UNITED STATES PATENT AND TRADEMARK OFFICE

APPLICATION NO.	FILING DATE	FIRST NAMED INVENTOR	ATTORNEY DOCKET NO.	CONFIRMATION NO.
10/582,736	06/13/2006	Simon Udo	ESQ0650.001	5018

Office Action Summary	Application No. 10/582,736	Applicant(s) UDO ET AL.	
	Examiner JENINE M. PAGAN	Art Unit 3728

DETAILED ACTION

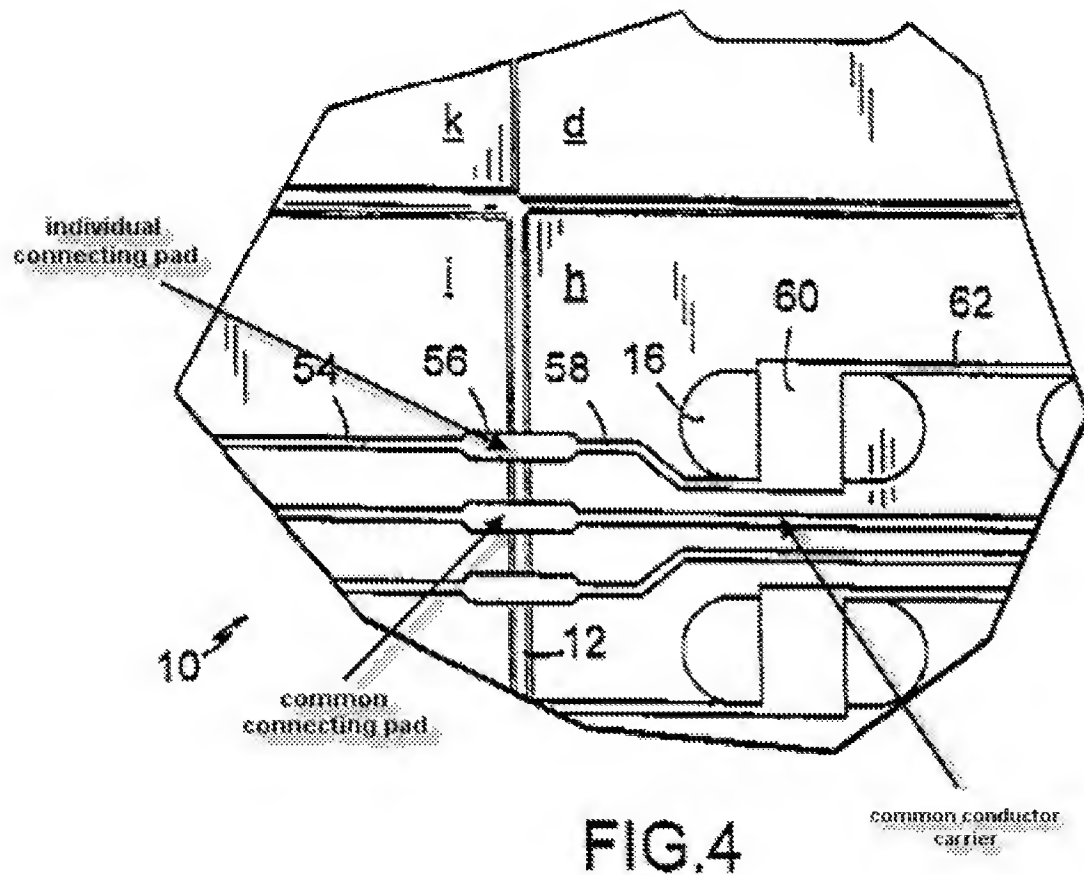
Claim 1: Ehrensvard discloses a blister package (Col 3:63-4:13 Fig. 4 and 5):
 an arrangement with a blister package 40 and a conductor carrier (58/60/62)/see figure above connected to it, wherein openings in the conductor carrier are

Claim 2: Ehrensvar discloses a blister package (Col 3:63-4:13 Fig. 4 and 5): each individual conductor (58/60/62), at its end opposite its associated individual connection pad 56, is connected with a common conductor 76 which is connected to a common connection pad (see figure above)

Claim 3: Ehrensvar discloses a blister package (Col 3:63-4:13 Fig. 4 and 5): the individual connecting pads 56 and the common connection pad (see figure above) are components of an interface, which upon insertion of the blister package arrangement 40 in a receiver device, effect a defined position

the conductor carrier (58/60/62)/(see figure above) includes the individual conductors (58/60/62) on the side facing away from the blister package 40, and

the conductor carrier (58/60/62)/(see figure above) is at least partially provided with an electrically insulating protective 90 on its side facing away from the blister package that covers at least the individual conductors and a common conductor (58/60/62)/(see figure above)

the conductor carrier (58/60/62)/(see figure above) includes the individual conductors (58/60/62) on its side facing toward the blister package 40, and that the side of the conductor carrier facing toward the blister package is provided with an electrically insulating layer 90 covering the individual conductors (58/60/62), and wherein the side of the electrically insulating layer 90 facing toward the blister package is connected with the sealing film 10 of the blister package

the conductor carrier (58/60/62)/(see figure above) projects over the blister package 40 at least on the side of the interface

the conductor carrier (58/60/62)/(see figure above) forms a first component (a) of the carrier that folds like a book, and a second component (j) forms at least one of an insertion opening 70 for each pocket of the blister package 40 and a common insertion opening for all pockets of the blister package, and may be folded about a fold line 12 with respect to the conductor carrier (58/60/62)/(see figure above) so that the blister package 40 is accepted between the conductor carrier (58/60/62)/(see figure above) and the second part, whereby each pocket of the blister package extends through an insertion opening 70 of the second component or all pockets of the blister package through the common insertion opening of the second component, and wherein the conductor carrier , the blister package, and the second component receiving the pockets of the blister package are connected with each other

the conductor carrier (58/60/62)/(see figure above) and the second component (j) project over the blister package 40 at least on the side of an interface of the conductor carrier with a receiver device 51

the conductor carrier (58/60/62)/(see figure above) and the second component (j) project over the blister package 40 on all sides

(58/60/62)/(see figure above) and the second component (j)

the conductor carrier (58/60/62)/(see figure above), the blister package 40 and the second component (j) receiving the pockets of the blister package 40 are adhered together

Claim 21: Ehrensvar discloses a blister package (Col 3:63-4:13 Fig. 4 and 5):
a blister package 40 having a plurality of pockets each configured to receive a tablet 44 therein; and a conductor carrier (58/60/62)/(see figure above) connected to the blister package 40, the conductor carrier comprising:
a cover 10 area positioned adjacent to each pocket in the blister package 40, each cover area defined by a stamped line 16 opening formed thereabout in the conductor carrier (58/60/62)/(see figure above);
at least two bridge parts 17/19 interrupting each stamped line 16 opening to connect each cover area to a surrounding conductor carrier area, the at least two bridge parts 17/19 positioned such that at least one bridge part is broken when a tablet 44 is pressed out from the corresponding pocket; and
an individual conductor (58/60/62) extending over the at least one bridge part, the individual conductor (58/60/62) configured to break along with the at least one bridge part 17/19 that is broken when a tablet 44 is pressed out from the corresponding pocket
